# Final Noise Abatement Design Report Technical Memorandum Noise Barrier C

## 495 Express Lanes Northern Extension (NEXT) Project

VDOT Project No. 0495-029-419; UPC 113414  
Federal Project No. NHPP-495-5(095)

HMMH Report Nos. 312870.002  
October 2023

**Figure 1**  
**Location Map for Common Noise**  
**Environments, Receptors,**  
**Build Contours and Barriers**

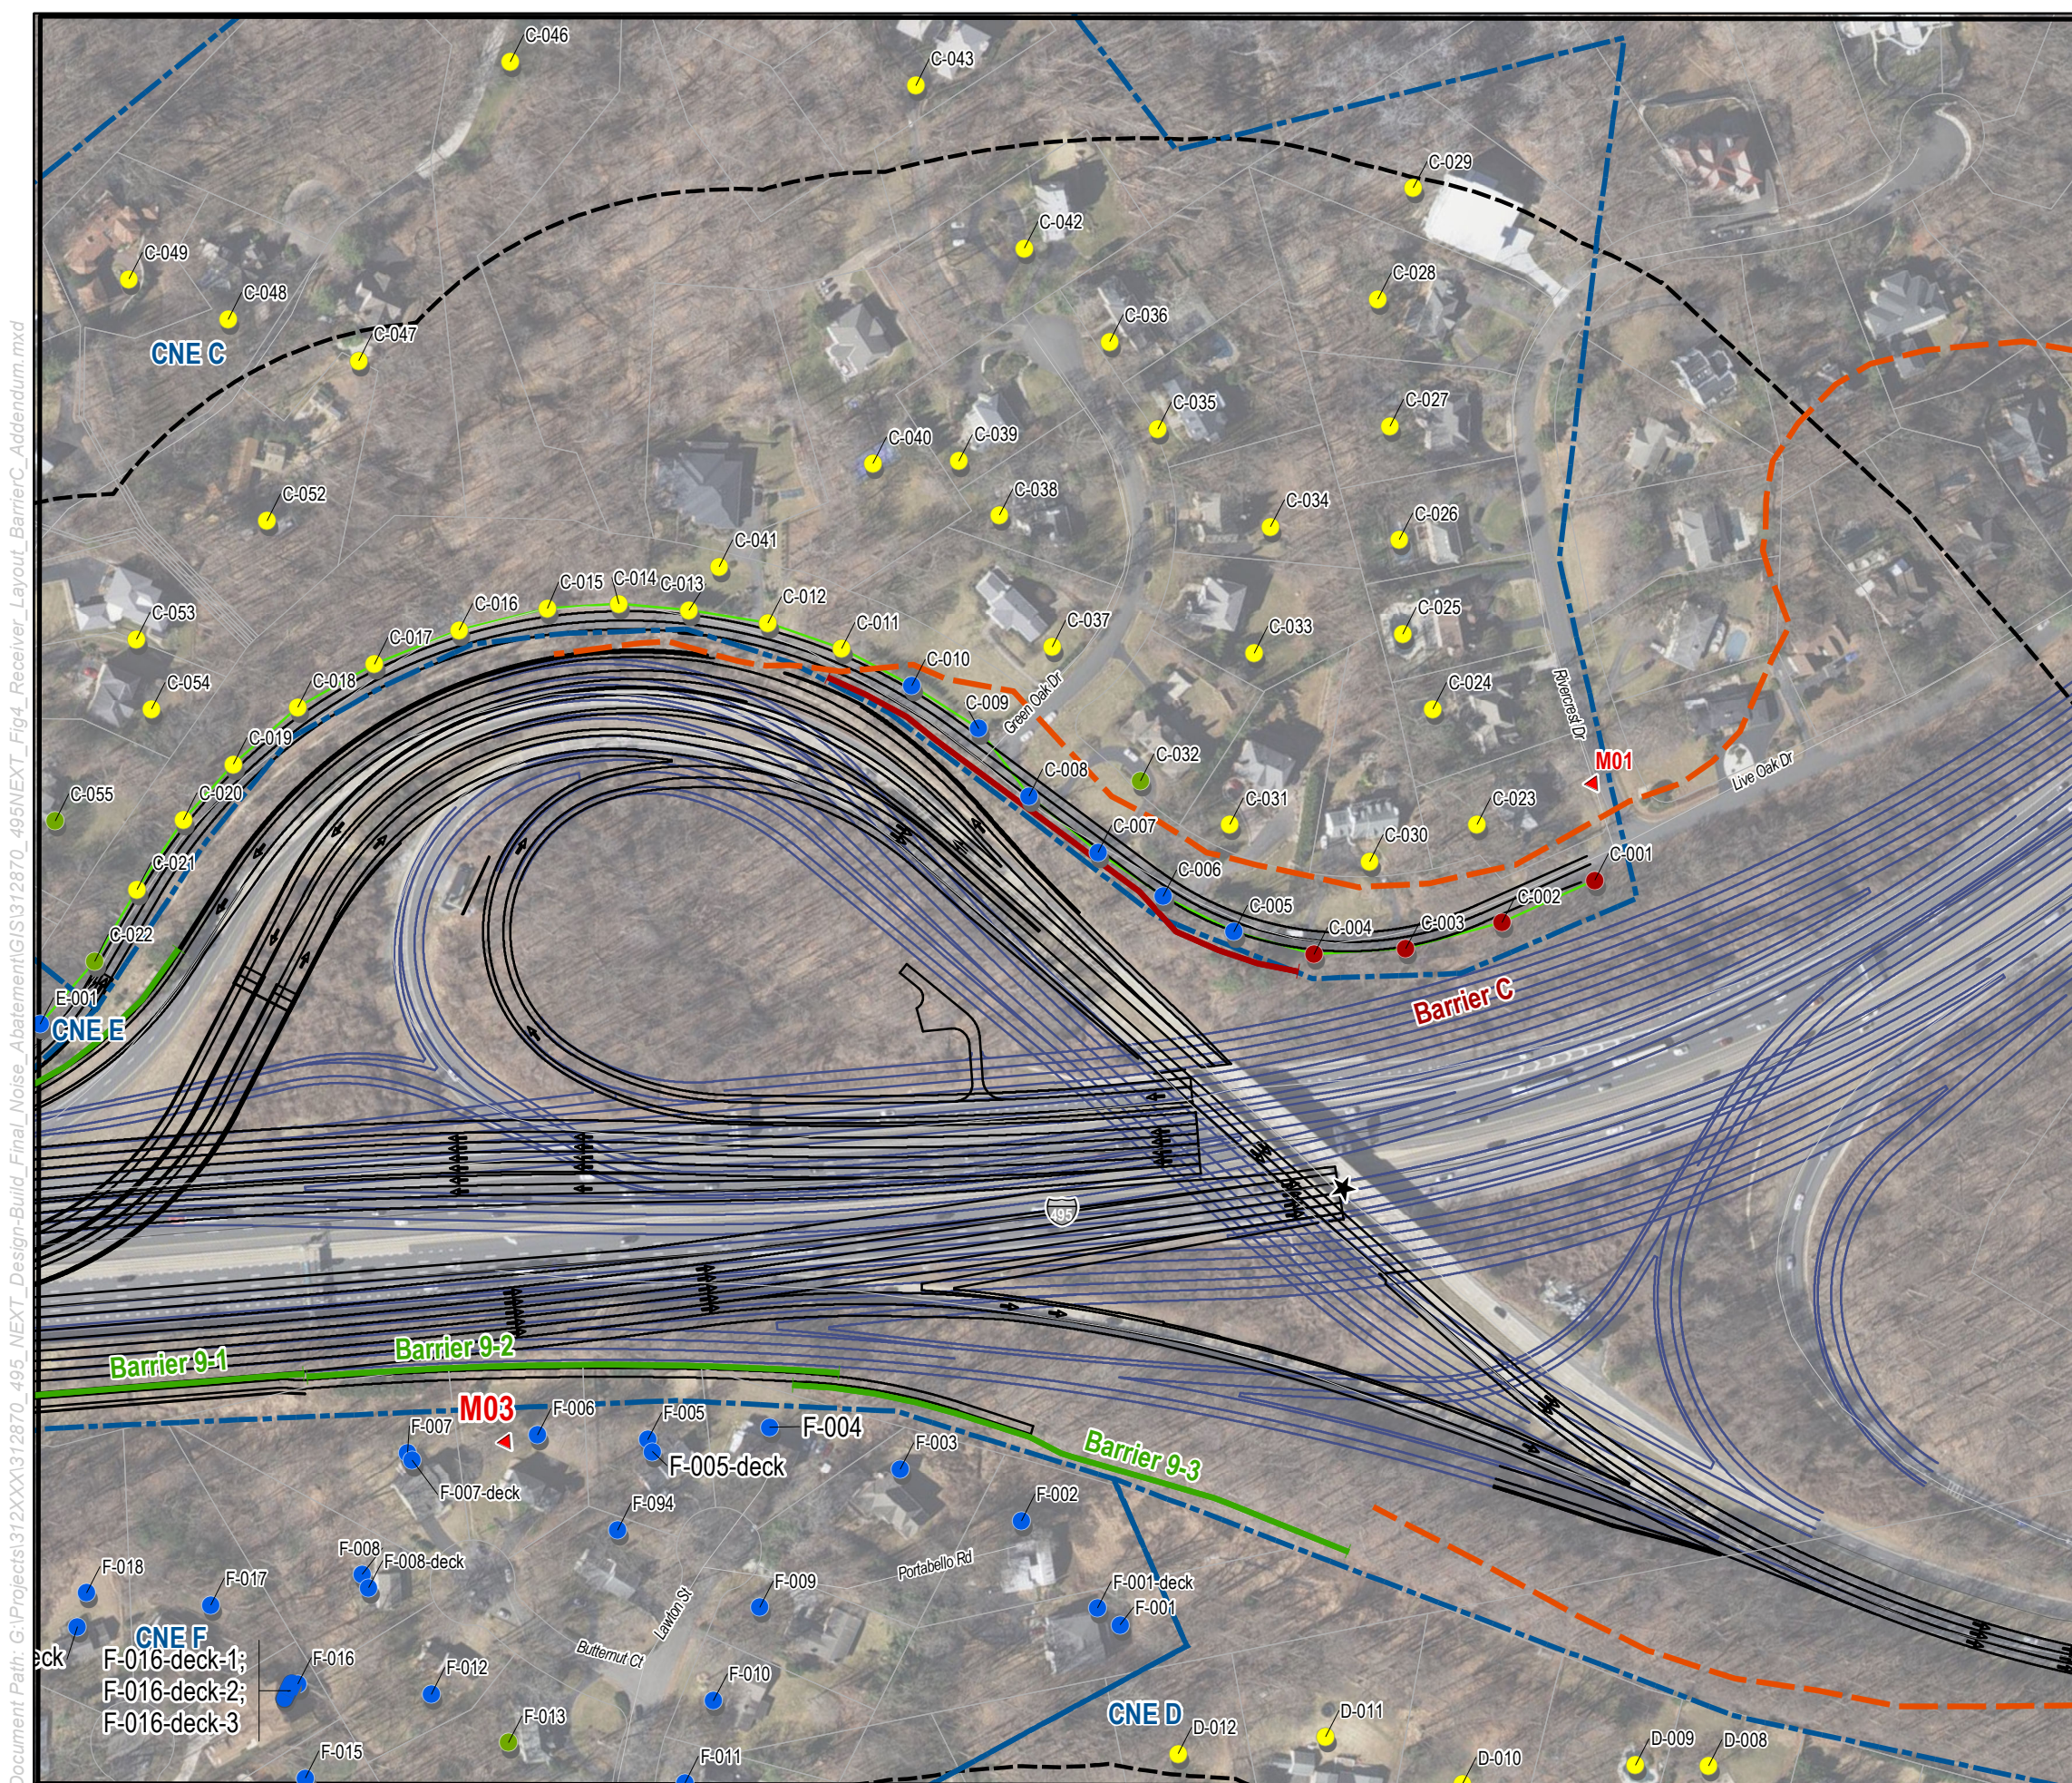
With direction from VDOT, the final design for Noise Barrier C was modified to address requests through community engagement, as input obtained during the voting process from the National Park Service and the adjacent noise-affected community requested that the barrier be shortened at the northern terminus and moved closer to I-495, where feasible, through partial mitigation. The total length of Noise Barrier C was reduced by approximately 300 feet and shifted south approximately 20 feet at its eastern end when compared to the design presented in the final NADR. The sound attenuation line was also maintained, at a minimum.

The modified design for Noise Barrier C would range in height from 13 to 18 feet (average height of 14 feet) and would have a length of 672 feet, equating to a surface area of 9,670 square feet. The barrier would benefit six out of the 10 impacted receptors associated with the Potomac Heritage Trail and would benefit one non-impacted residential receptor. The barrier would also meet VDOT's acoustical feasibility goal. When compared to the final design presented in the NADR, it should be noted that a total of two impacted receptors (Receptors C-003 and C-004) would no longer benefit from Noise Barrier C due to the reduction in length. To maintain benefit to receptor C-032, as presented in the NADR,

heights were increased by one foot between Stations 14+00 and 15+50. The barrier would provide 7 dBA or more of noise reduction to six impacted receptors, which meets VDOT's noise reduction design goal. With a surface area per benefited receptor value of 1,381 SF/BR, Noise Barrier C meets VDOT's cost-effectiveness criteria of 1,600 SF/BR. Therefore, Noise Barrier C would also be considered reasonable.
